Central Planning Authority

Agenda for a meeting of the Central Planning Authority to be held on **February 02, 2022 at 10:00 a.m. in Conference Room 1038, 1st Floor, Government Administration Building, and Elgin Avenue.**

CPA/03/22

Figure 1: LIS 2018 Aerial imagery showing application site outlined in red

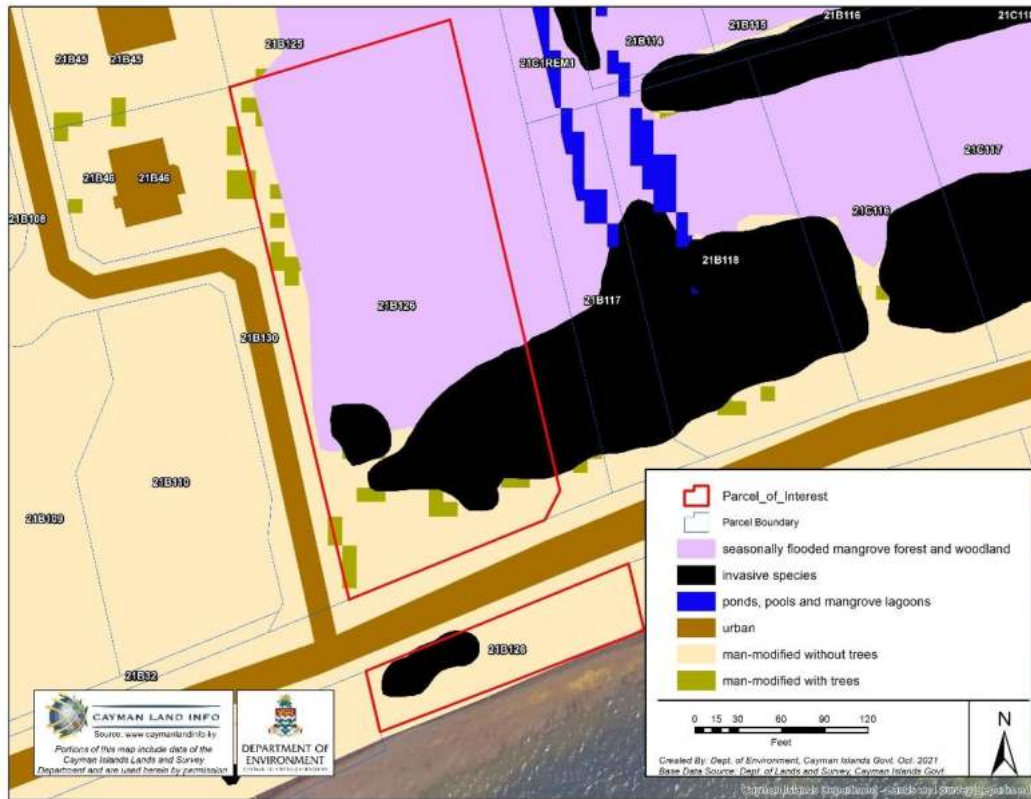
The application site is located within the South Sound drainage basin and consists of seasonally flooded mangrove forest primary habitat, as shown in Figures 1 and 2. The site has planning permission for an apartment complex (Planning Ref: P18-1054); planning permission was granted in January 2019 (CPA/02/19 item 2.5). Therefore, the application site is committed to development. Notwithstanding this, the DoE wishes to again highlight the importance of mangrove wetlands in terms of their drainage and ecological functions. Mangroves are protected under the National Conservation Act (2013) and the Mangrove Conservation Plan (2020).

Since the proposed development will continue to fragment the South Sound drainage wetland, further reducing its ecological capacity as a storage and catchment basin for the surrounding area, it is strongly recommended that a stormwater management plan be developed. The stormwater plan should ensure that any site derived runoff is handled on-site. It is also recommended that the existing mature vegetation be retained to the greatest extent possible and incorporated into the landscaping scheme. Native vegetation is best suited for the habitat conditions of the Cayman Islands resulting in vegetation that requires less maintenance which makes it a very cost-effective choice.

Figure 3: Applicant's site plan overlaid on 2018 LIS aerial imagery with a 50-foot coastal setback buffer shown in yellow and a 75-foot coastal setback buffer (required under the Development & Planning Regs 2020) shown in orange. The pool and nine of the units are in breach of the 75-foot setback.

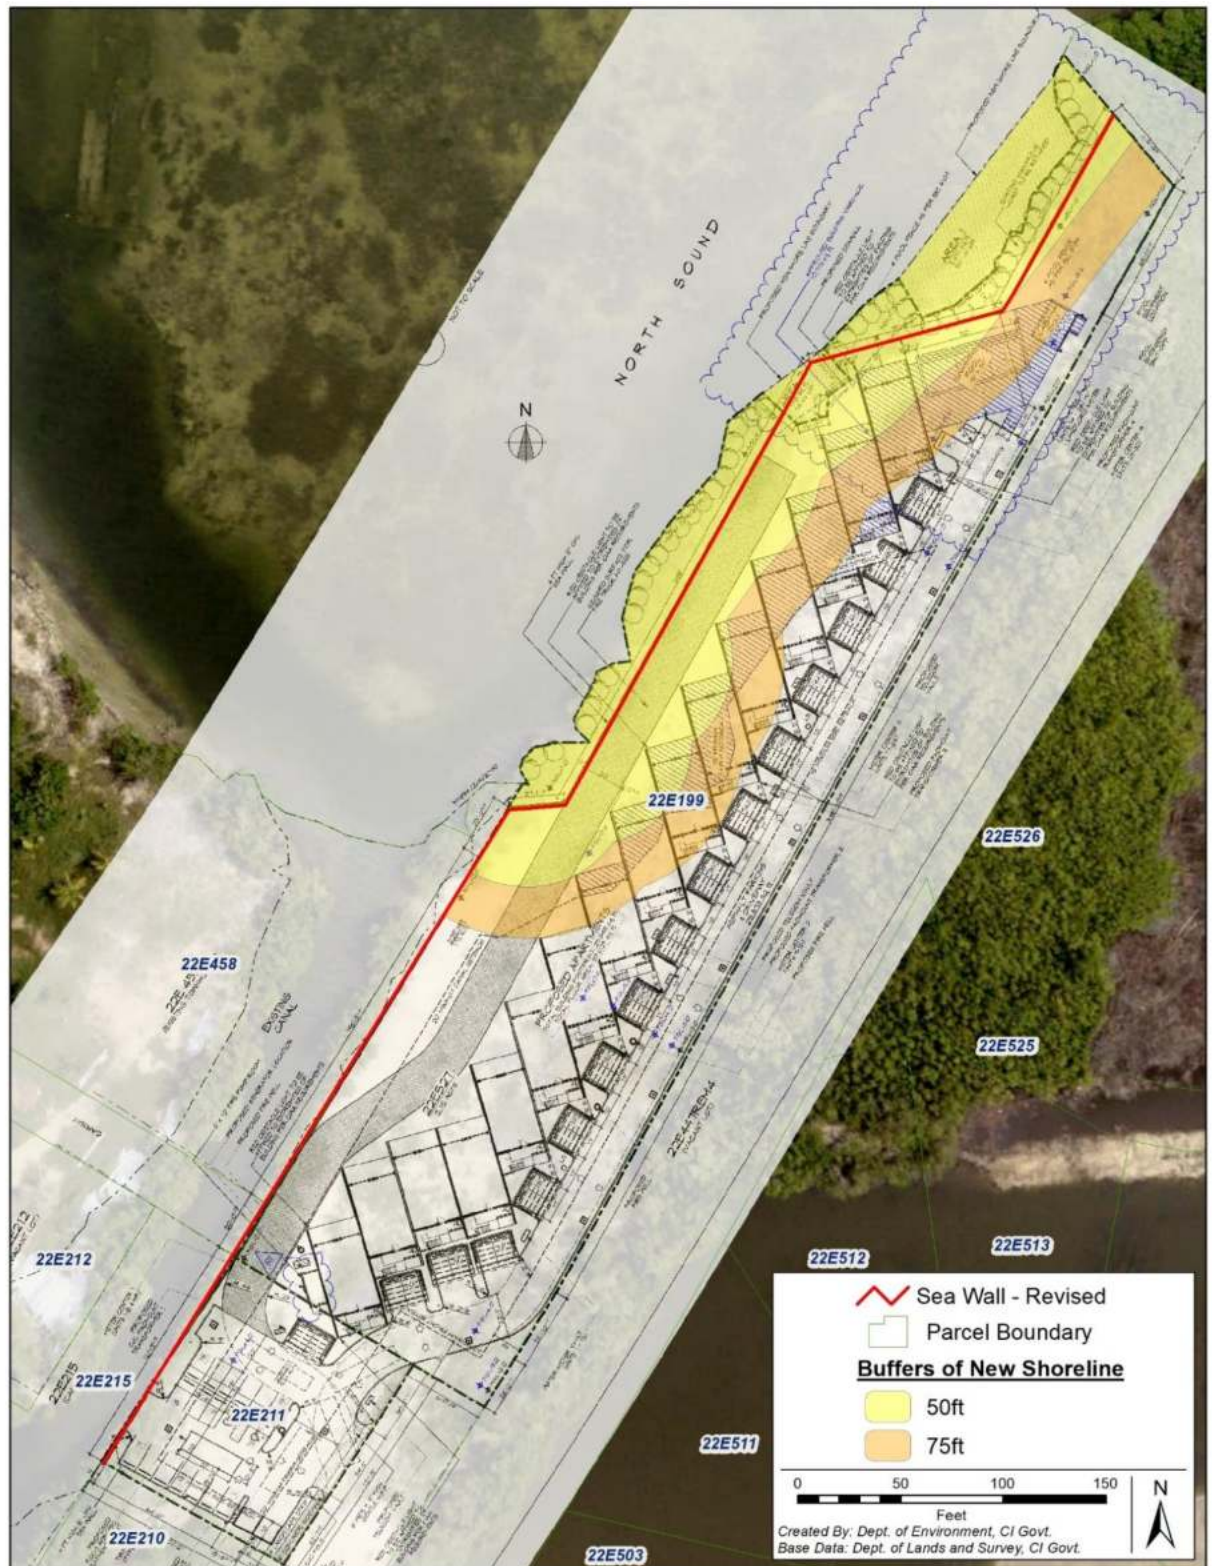
*Under the Development & Planning Regulations (2021), the setback for mangrove coastlines is 75 feet from the Mean High Water Mark. As expressed in our previous comments dated 27 February 2020, the Department is extremely concerned with the increasing prevalence of inappropriately sited developments on coastal properties. Amenity considerations are not the only factor to be assessed when determining the appropriateness of a development within the context of its environmental setting. Coastal erosion, flooding from wave activity during storm and hurricane events, the effects of elevated water levels during King Tides and the effects of sea-level rise should all be **fundamental considerations** when assessing the suitability of coastal land for development.*

*The effects of coastal erosion and seawater inundation are becoming more and more evident, with the effects starting to be felt by those properties/developments that are positioned too close to the High Water Mark. The Development and Planning Regulations provide a framework for prescribing coastal setbacks, with the setbacks being defined as a **minimum** i.e. in some areas it might be appropriate to increase the setbacks further, not reduce them. Figure 3 shows the location of the proposed buildings on the application site, with 50-foot and 75-foot setbacks delineated. The proposed pool and eight of the proposed*

units are in breach of even a 50-foot setback, with 75 feet being the legally-required minimum for this site.

Figure 4: Extract from Applicant's site plan showing proposed coastal boundary.

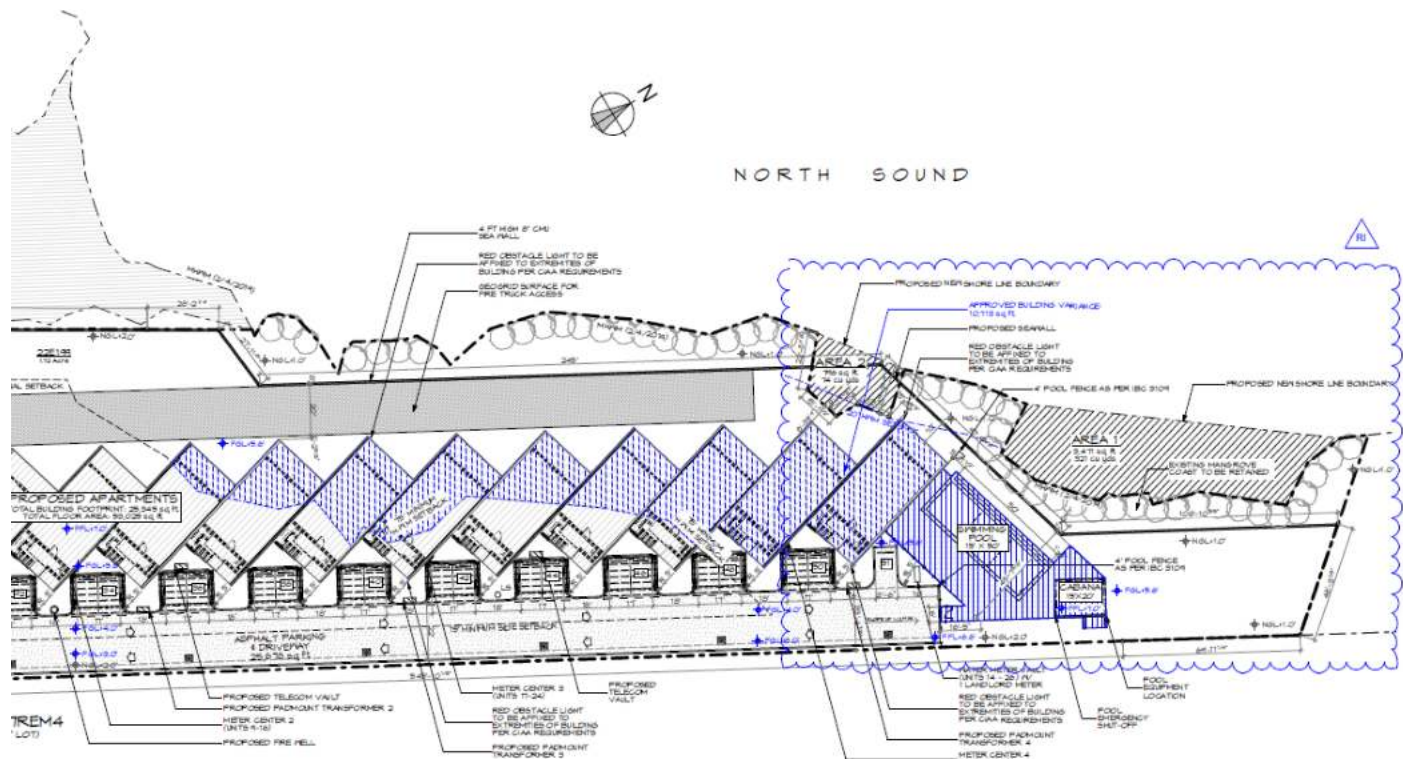
The position of the proposed shoreline boundary shown on the application's site plans (see Figure 2) had not been approved. Areas 1 and 2, shown on Figure 4, were the subject of Coastal Works application to fill the Crown-owned seabed and install seawalls. This Coastal Works application was refused permission by Cabinet. The Department recommended the refusal of the Coastal Works proposal on the basis that the Applicant had stated that the seawalls and the filling are to 'avoid setback issues' and 'prevent further erosion by the sea' in an area that was filled mangroves (stated in the Applicant's Coastal Works application cover letter). The Department believes that this approach sets a precedent for seawalls to act as a form of land reclamation in order for development projects to meet artificial setbacks. This form of land reclamation will lead to greater impacts on marine habitats and the coastline and the potential for greater susceptibility of the development to coastal erosion, storm impacts etc. Further, at that time the proposed areas of filling still only resulted in a coastal setback of approximately 20 feet from the Mean High Water Mark (rather than the minimum of 75 feet which the Planning Regulations require).

The works which are detailed in the Coastal Works application (which was subsequently refused permission) are the subject of a court case/enforcement action. On 23 June 2020,

Figure 2: Showing site plan overlaid onto DOE's 2013 Habitat Map (Plan Source: Abernathy and Associates, Dec 2021)

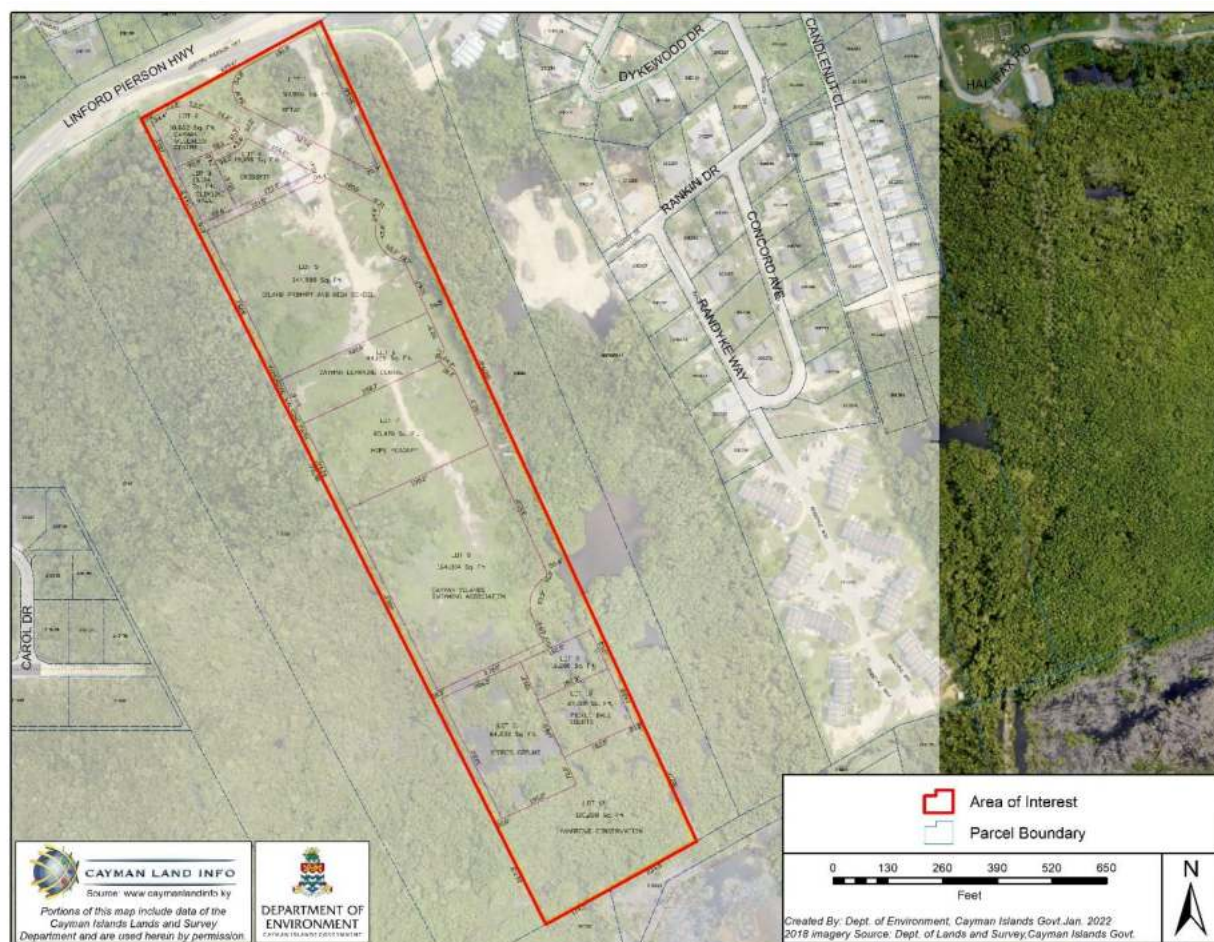
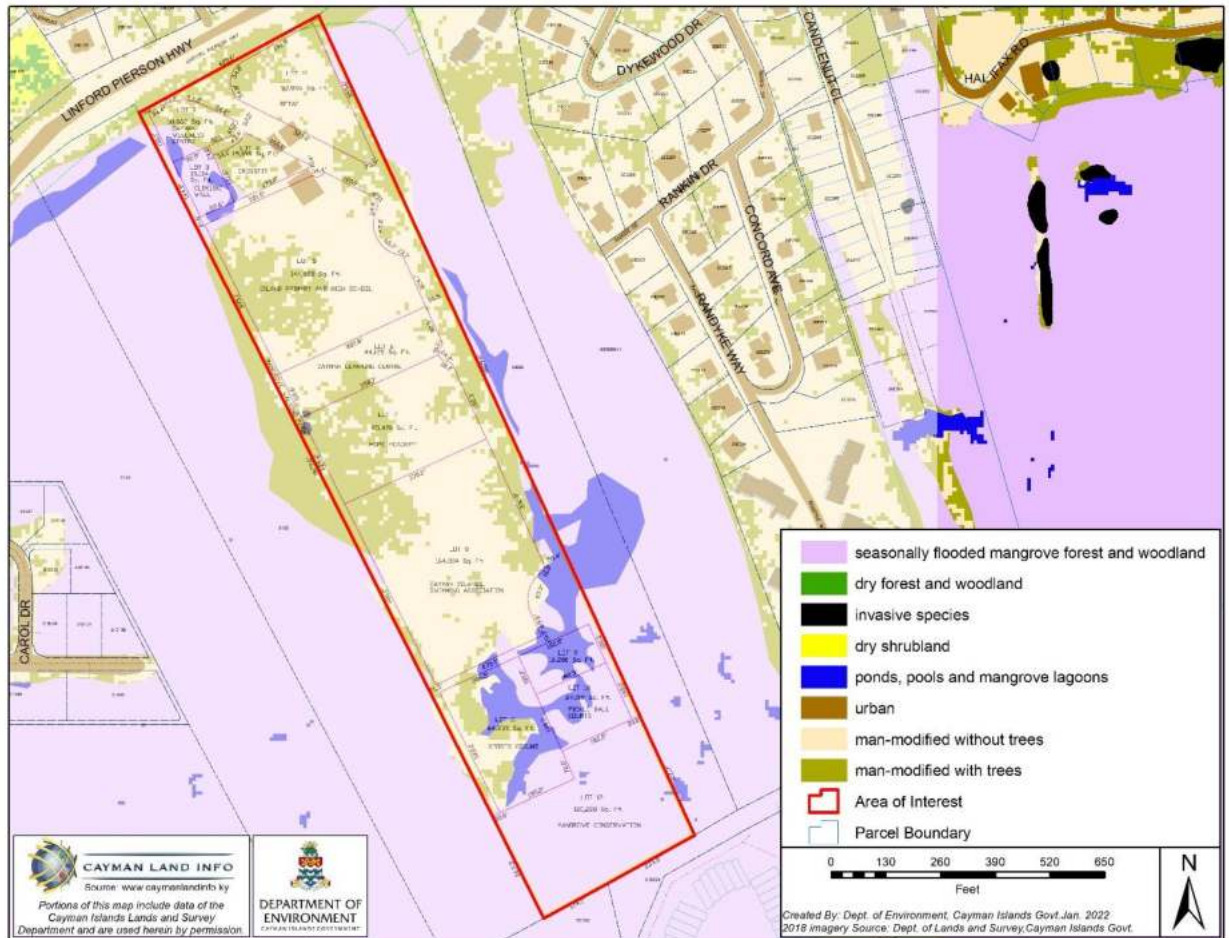
The application site is predominately man-modified with seasonally flooded mangroves in the southern portion of the parcel as shown in Figures 1 and 2. Mangroves are protected under Schedule 1, Part 2 of the National Conservation Act (2013), with an adopted Mangrove Conservation Plan (2020) which provides additional information.

Mangrove wetlands are a critical part of our natural environment, providing several ecosystem services which include assisting to mitigate the effects of climate change. As one of the most productive terrestrial ecosystems, mangrove wetlands are extremely biodiverse and provide habitat and food for an immense variety of species. They also function as natural sponges that trap and slowly release surface water. Inland wetlands in urban areas are particularly valuable, counteracting the greatly increased rate and volume of surface-water runoff from areas of hardstanding and buildings. Trees, root mats and other wetland vegetation also slow the speed and distribution of storm waters. This combined water storage and braking action lowers flood heights and reduces soil erosion. In addition, inland wetlands improve water quality by filtering, diluting, and degrading toxic wastes, nutrients, sediments, and other pollutants.

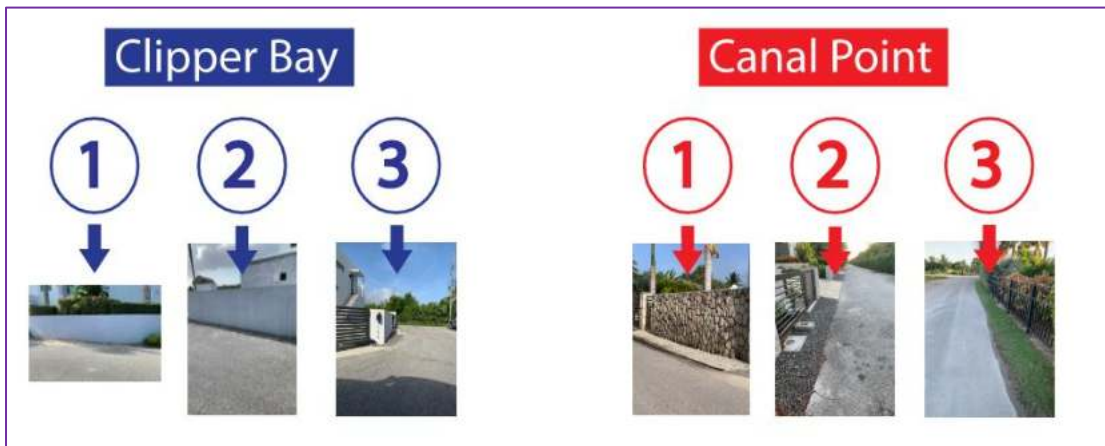
The applicant would like to restore this section of the canal to its original state by removing approximately 4' of muck that has settled at the bottom of the canal since it was originally dredged. This material will be removed offsite once it has dried.

The operations plan is attached to this application which outlines the proposed method and duration. Drawing A1-00D depicts the area of the canal that the applicant would like to dredge."
